DEVELOPMENT APPLICATION ASSESSMENT REPORT

| Application Number: | DA2022/1229 |

| Proposed Development: | Demolition works and construction of a dwelling house including swimming pool |

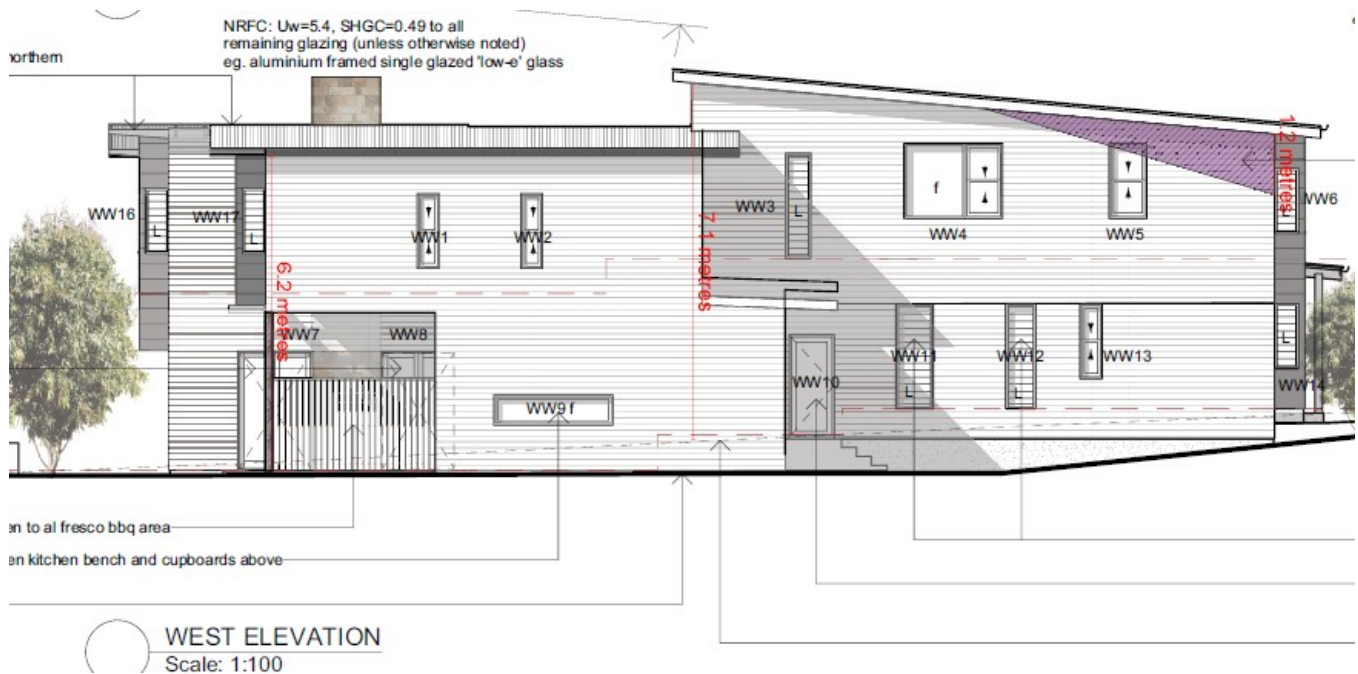
B3 Side Boundary Envelope

Description of non-compliance

There is an envelope encroachment on the western elevation, for up to 1.2m, as shown in the below extract:

The building is well setback with the top floor articulated, the minor encroachment is not considered to result in a building of excessive visual scale.

The area of envelope encroachment does not have a direct impact with regards to views, overshadowing or privacy. Adjoining properties will received sunlight to POS in accordance with the WDCP.

The building is generally stepped down with the site, with stepping of the floor levels in response to the gentle slope of the land. It is not considered necessary to step in further the section of non-compliant building due to the minor nature of the encroachment and absence of impact.

Having regard to the above assessment, it is concluded that the proposed development is consistent with the relevant objectives of WDCP and the objectives specified in s1.3 of the Environmental Planning and Assessment Act, 1979. Accordingly, this assessment finds that the proposal is supported, in this particular circumstance.
